**ANGEL PLACE  
LEVEL 8, 123 PITT STREET  
SYDNEY NSW 2000**

27 April 2021

## **29-57 CHRISTIE STREET, ST LEONARDS | DA-2020/171 | RESPONSE TO PRELIMINARY ASSESSMENT**

Figure 1 Updated view analysis

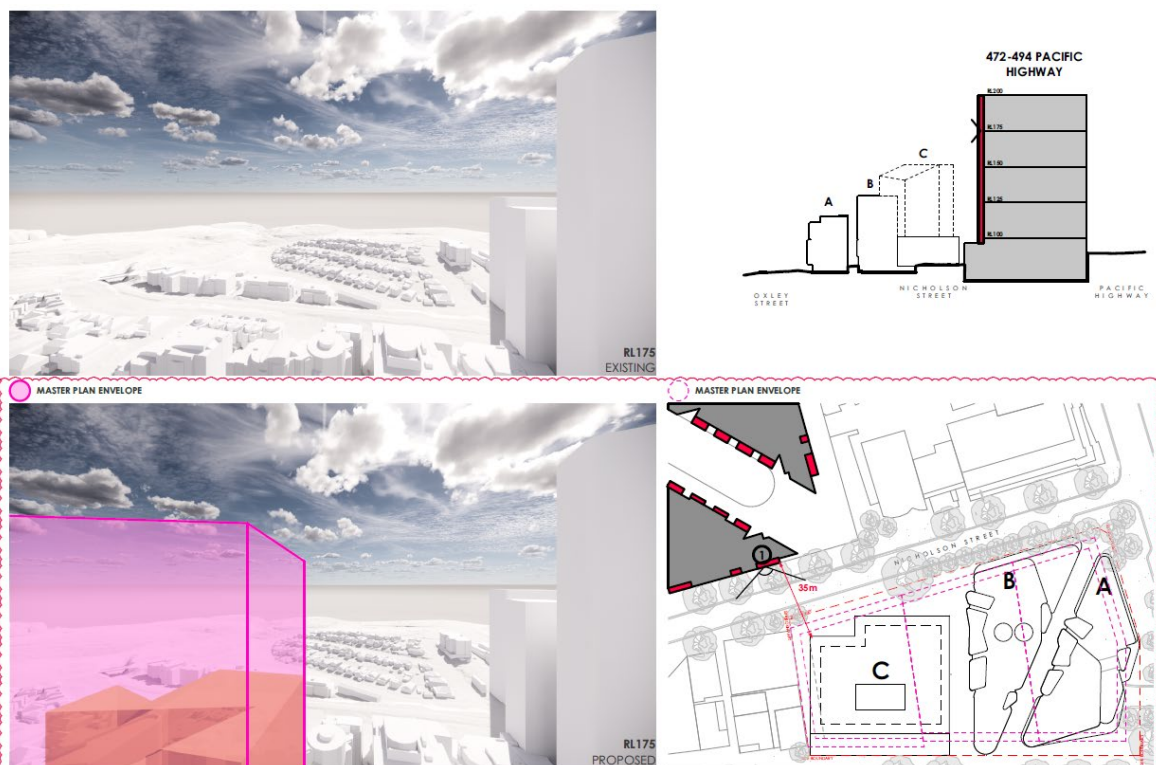
Comment	Response
<b>1. Built Form</b>	
<p><b>Building Height and Floor Space Ratio (FSR)</b></p> <ul style="list-style-type: none"> <li><i>View analysis: The submitted view analysis is to be expanded to show the loss of view resulting from the non-compliant section of Buildings A and B with the height control under the St Leonards and Crows Nest 2036 Plan.</i></li> </ul>	<p>The view analysis prepared by Fitzpatrick + Partners has been updated to show the St Leonards and Crows Nest 2036 Plan (2036 Plan) building envelopes to facilitate a comparison between those permitted under the 2036 Plan and the proposed building envelopes.</p> <p>An extract of the view analysis is provided at <b>Figure 1</b> below.</p> <p>Refer to drawing numbers DA 42-55, Rev D at <b>Appendix A</b>.</p>
<ul style="list-style-type: none"> <li><i>Clause 4.6: The Sydney North Planning Panel will consider the Clause 4.6 written requests to vary the height and FSR development standards based on merit. These justifications should be succinct. As per comments above, the Clause 4.6 is to be revised to address the impacts of a compliant scheme with the building heights indicated under the 2036 Plan for Buildings A and B in terms of views, privacy amenity, and solar access for impacted existing and approved surrounding residential development.</i></li> </ul>	<p>The clause 4.6 variation request for height has been revised to assess the impacts of the proposed height variation in comparison to a development with a compliant LEP height and a development with a compliant building height under the 2036 Plan.</p> <p>The assessment demonstrates that the proposed height of buildings is suitable for the site in the context of the locality and will result in negligible impacts beyond those associated with a height compliant with the 2036 Plan. In regard to view loss, the proposed development will result in a better outcome for the residential units to the north-east of the site in relation to Building C when compared to the allowable height under the 2036 Plan. The minor exceedance in height beyond the 2036 Plan envelope for Building A and B does not result in significant view loss from the residential units to the north-east, noting that views to the North</p>

Comment	Response
	<p>Sydney CBD will be retained from the residential units of 472-494 Pacific Highway.</p> <p>The amended clause 4.6 variation request for building height is provided at <b>Appendix D</b>.</p> <p>A clause 4.6 variation request for FSR was submitted with the original DA and remains applicable to the proposed development.</p>

The above image shows that views will be retained from the upper levels of 472-494 Pacific Highway as a result of the proposed Building C envelope (shown in orange), in comparison to an envelope permitted under the 2036 Plan (shown in pink).

Figure 2 Site setback analysis

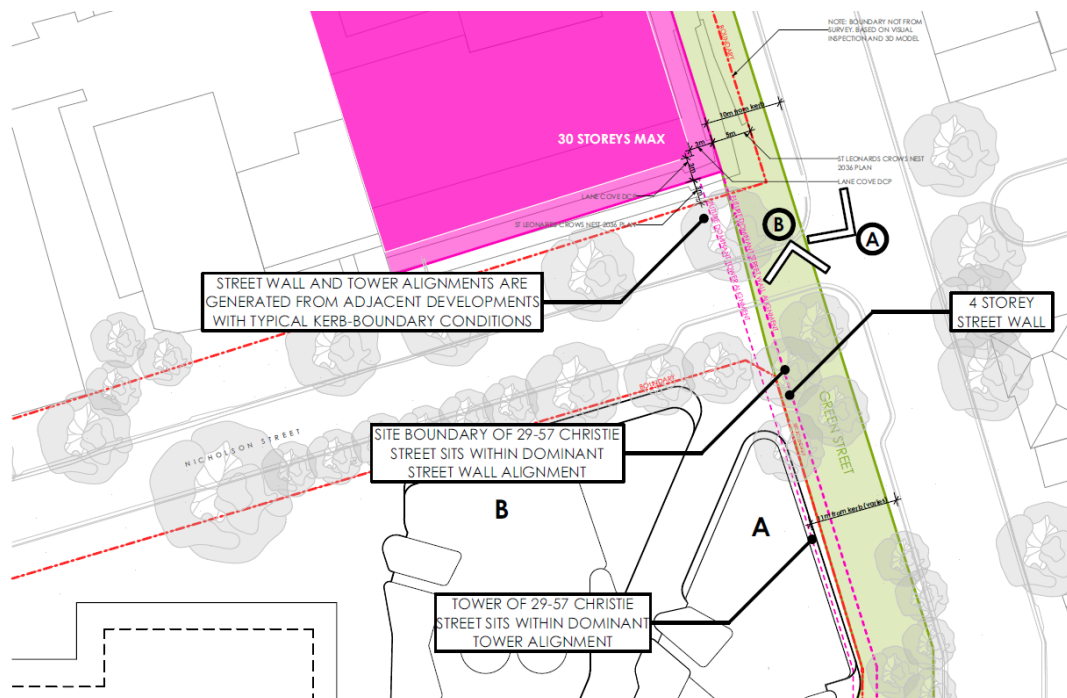
- 2m setback to Oxley Street for the northern wall to Building A is inconsistent with 5m setback under the 2036 Plan and is not supported due to the length of the non-compliant wall and associated increase in perceived and actual bulk at the pedestrian scale.

The proposed setback at the northern wall of Building A is considered appropriate in the unique circumstances of the site. The project architect has undertaken extensive investigations to inform the siting of the built forms including analysis of site boundaries and building alignments of other sites along Oxley Street.

The analysis presented in drawing RFI 01 and RFI 02 of the architectural package at **Appendix A** clearly demonstrates that the Oxley Street boundary of the sites to the north-east of the site align with the public footpath along Oxley Street, meaning a 5m setback from this boundary will provide additional amenity to pedestrians at this location. In contrast, a 10m-wide landscaped strip sits between the Oxley

<p>Street boundary of the subject site and the road reserve which provides a generous setback to the proposed built form. The 10m-wide landscaped strip will be the subject of public domain upgrades and tree planting as part of the DA. These unique conditions of the site do not warrant a further 5m setback from the site boundary as it is considered that the proposed siting meets the intent of the setback control and aligns with the dominant building alignment along Oxley Street.</p> <p><b>Figure 2</b> below demonstrates the appropriate siting of the development in the context of the existing building at 40 Oxley Street and in a future scenario if that site was redeveloped.</p> <p>Refer to drawing RFI 01 and RFI 02 at <b>Appendix A</b> for further information.</p>
--	--

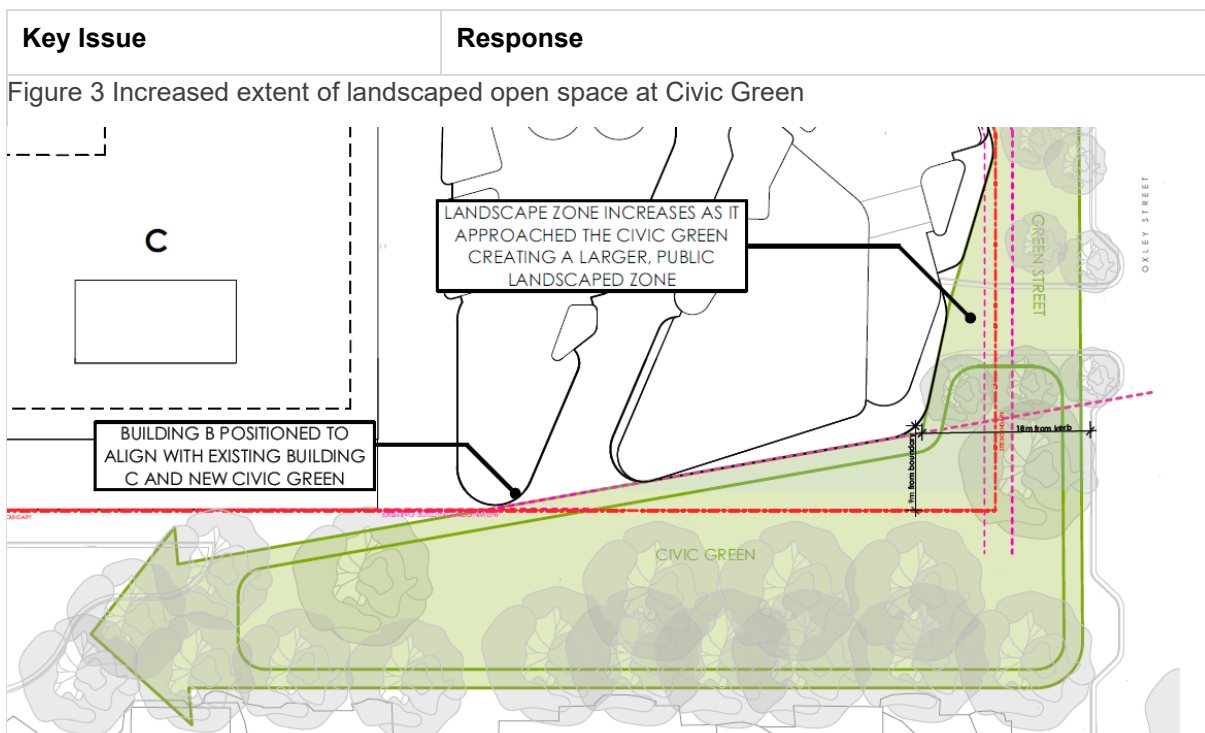
Height of buildings and associated amenity impacts including overshadowing, privacy and view impacts	<p>The proposed height of buildings A and B and envelope for Building C has been guided by the built form controls contained in the 2036 Plan.</p> <p>The objectives of the 2036 Plan include the requirement to contain taller buildings between St Leonards Station and Crows Nest Metro Station. In addition, the 2036 Plan includes an action to provide appropriate transitions in height to adjoining low scale residential areas. The heights of the proposed three buildings have been deliberately designed to provide the lowest built form closest to the low-density locality to the south across Oxley Street and the highest built form closest to St Leonards Station and the taller buildings fronting the Pacific Highway to the north.</p> <p>It is noted that the height of Building C is well below the 25-storey height control nominated for the site under the 2036 Plan. Whilst the height of Building A and B are above the 6 and 11-storey height limits for the site under the 2036 Plan, the proposed height of 8 and 12 storeys for Building A and B respectively do not result in any material adverse impact when</p>

Key Issue	Response
	<p>compared with a 'compliant' building envelope under the 2036 Plan.</p> <p>The additional view analysis provided at <b>Appendix A</b> demonstrates that the proposed heights result in a similar or better view impact in comparison to a compliant scheme under the 2036 Plan.</p> <p>The proposed height variation retains a greater degree of view sharing from the upper-level residential units at 472-494 Pacific Highway in relation to Building C, in comparison to a building with a height of 25-storeys which would be compliant under the 2036 Plan.</p> <p>In addition, the proposed building height of Build A and B retain views to the North Sydney CBD from the residential units at 472-494 Pacific Highway.</p> <p>The amended clause 4.6 for height provided at <b>Appendix D</b> provides further justification for the proposed height of buildings, including lack of adverse environmental impact in relation to privacy, overshadowing and view loss.</p>
